**Draft Environmental and Safety  
Analysis of a Proposed Low-Level  
Radioactive Waste Disposal Facility in  
Andrews County, Texas**

**August 2008**

**Radioactive Materials Division**

**TEXAS COMMISSION ON ENVIRONMENTAL QUALITY**

**Figure EA-8: Approximate Contours of Saturated Conditions in Dockum Red Bed Materials (X,Y in Hundreds of Feet)**  
Note: Bottom of the FWF Unit Specified by Four Points (X,Y): (48,52); (52,61); (64,56); and (60,48).

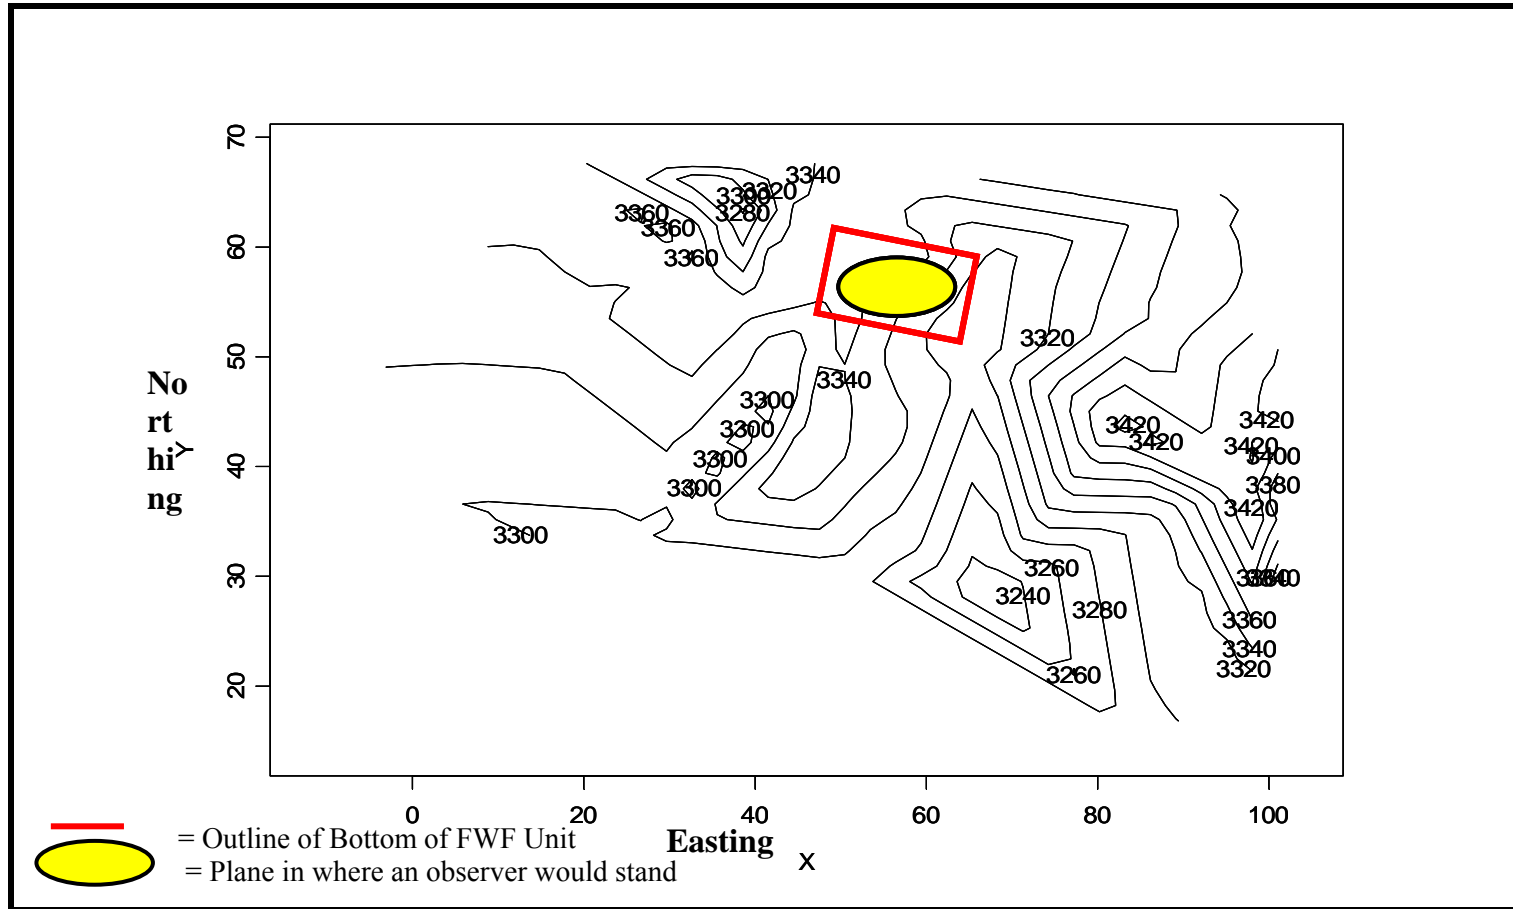
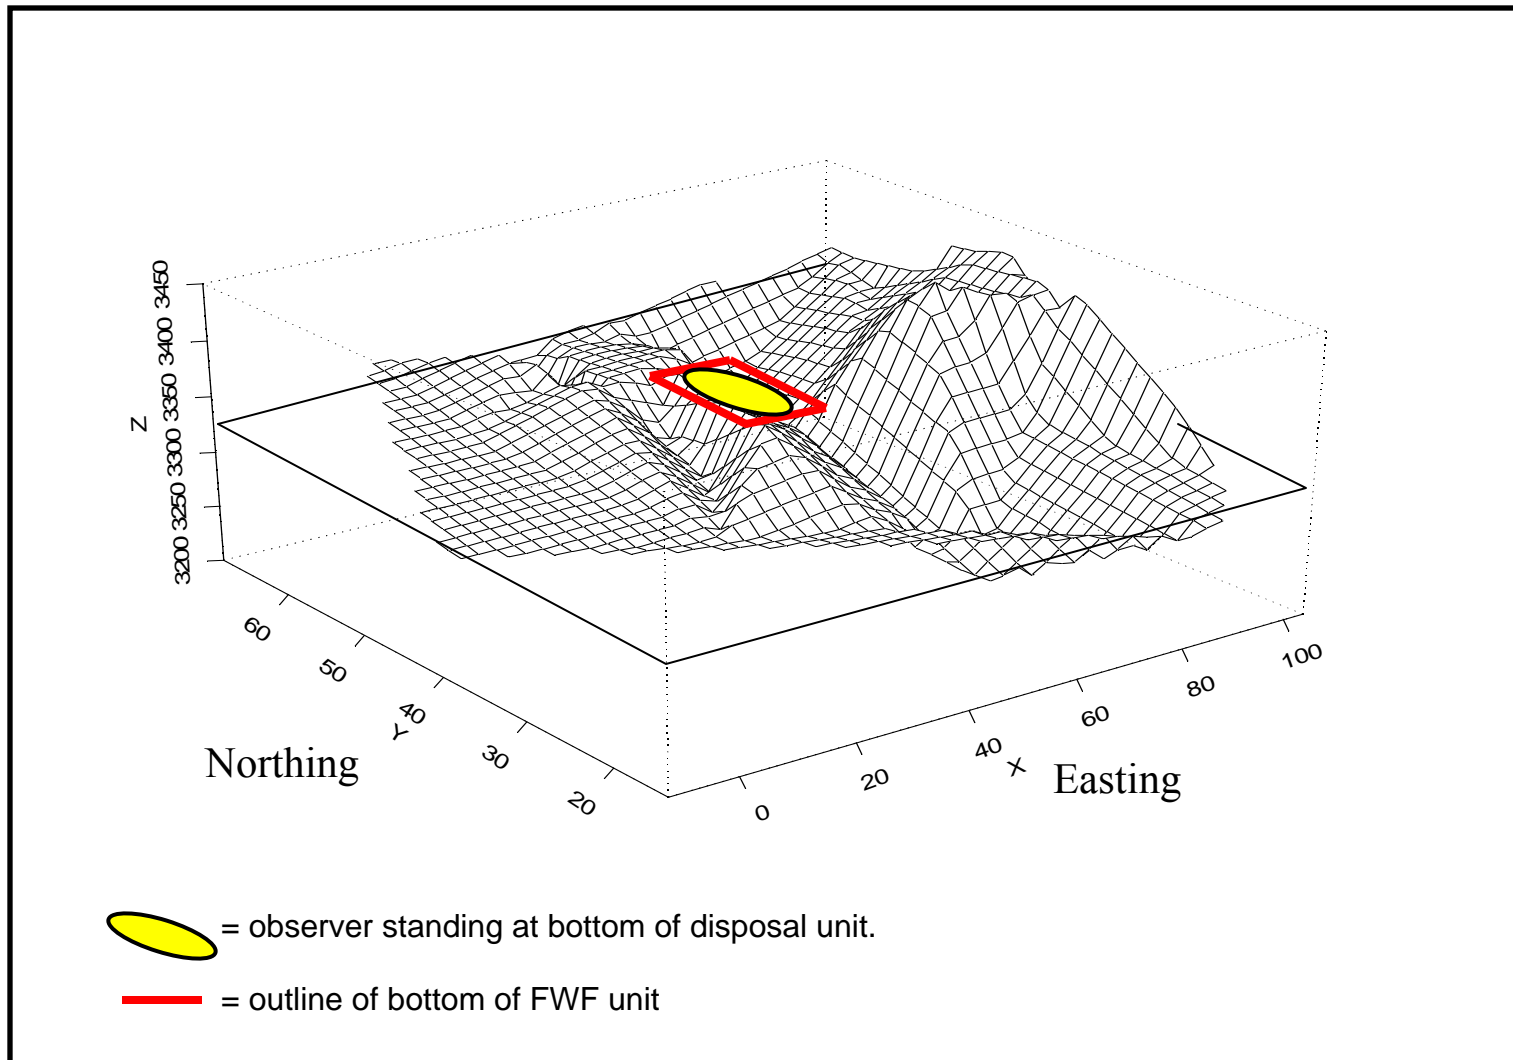
Figure EA-8 shows a contour map of that approximation, again with the boundaries of the FWF unit appended. Figure EA-9 shows the surface map of that approximation with the boundaries of the bottom surface of the proposed FWF disposal unit appended. In constructing these maps, the historical stabilized elevation of 3,350 feet in monitoring well 6-B2 was used as the relevant datum, rather than the most recent elevation of 3,339 feet for that well shown in Table 6-2 of the application.

While the maps in Figures EA-8 and EA-9 overestimate the elevations of the lower table, they may approximate the location of that water table at some future time as the subsurface conditions attempt to equilibrate to the current, measured, potentiometric field. Also, this overestimation may be ameliorated somewhat by the fact that the data in Table 6-2 of the application does not account for the thickness of any capillary fringe. Figure EA-9 explicitly shows the three-dimensional character of the lower water table in the Dockum, and the location of the proposed FWF disposal unit above the lowest elevation of that water table, flanked on three sides by water at higher elevations. Figure EA-8 indicates that a 3,340 foot elevation contour partitions the footprint of FWF unit into two roughly equal areas. Another 3,340 foot contour to the left of this contour indicates that a higher head elevation (approximately 3,350 feet) may exist near the western boundary of the unit.
